Addendum No. 1

RE: Contract # C204434

BRIDGE 138 AND BRIDGE 139 OVER THE NEUSE RIVER ON SR-1470.

The following revisions have been made to the Structure plans.

STEEL PILE POINT DETAIL

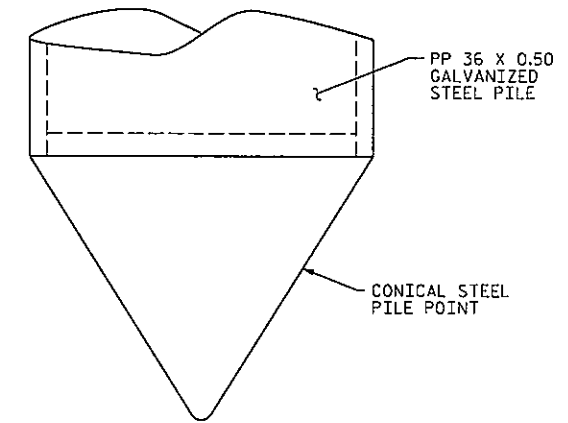
Sheet No.	Revision
S1-31	Revised to show a Steel Pile Point on the end of the 36" Steel Pipe Pile, rather than a Pipe Pile Plate
